HVDC Grid Connection System

**STAKEHOLDER CONSULTATION PROCESS OFFSHORE GRID NL**

Type: Overview topics and summary of discussions  
Filename: ONL TTB-05443  
Version: V1.0  
Pages: 41  
Date: 24 May 2020

Figure 2 – Illustrative effect of overplanting the load profile of a wind farm

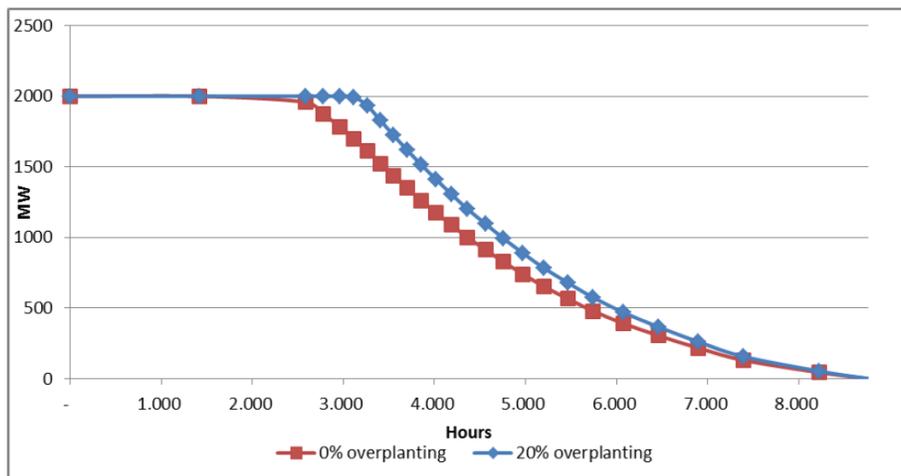
Furthermore the amount of overplanting was discussed. The OWF and BLIX experts discuss that 15% overplanting is high, since wake losses will become an issue; 5-10% is considered normal. A cap of 15% overplanting is considered by TenneT in cable design since it is highly unlikely this will limit overplanting capabilities for the wind farm developers.

TenneT proposes to set the maximum overplanting in the IJmuiden Ver area to 15%.

An overplanting rate between 0-15% gives maximum flexibility to the offshore windfarms to optimize their wind farm lay-out and business case.
